Board of Zoning Appeals

Tuesday, March 10, 2026

BZA PL-20254278 - 114 Prospect Street

13.11.7 BZA Hardship Criteria: Variance to reduce the rear setback.

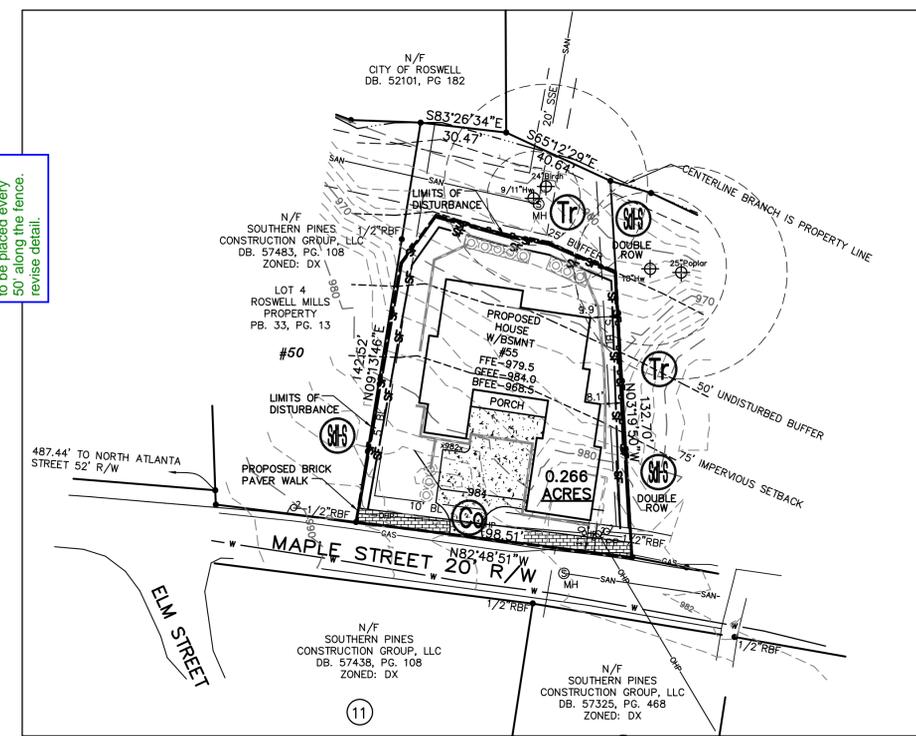
trenching prohibited in root zone of preserved trees. Keep out tree protection area signs to be placed every 50' along the fence, revise detail.

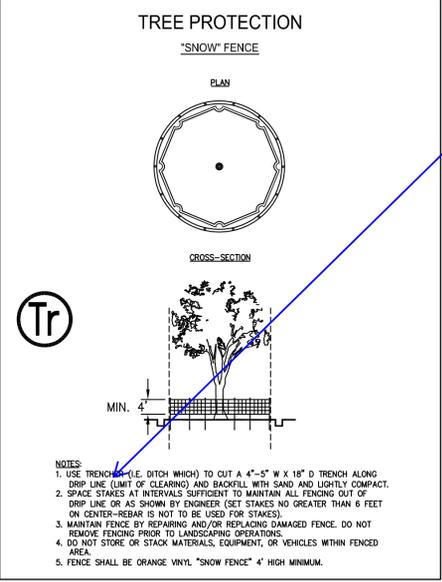
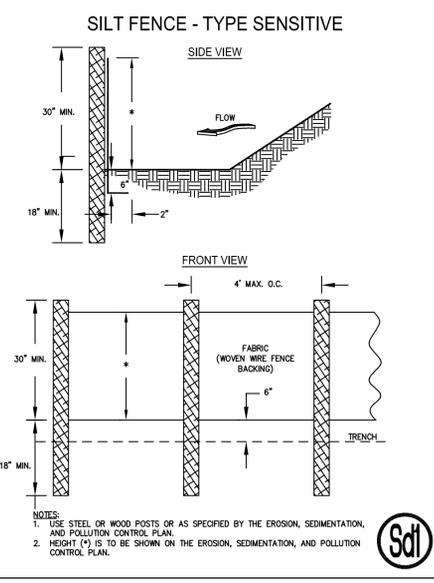
trenching prohibited in root zone of preserved trees. Keep out tree protection area signs to be placed every 50' along the fence. revise detail.
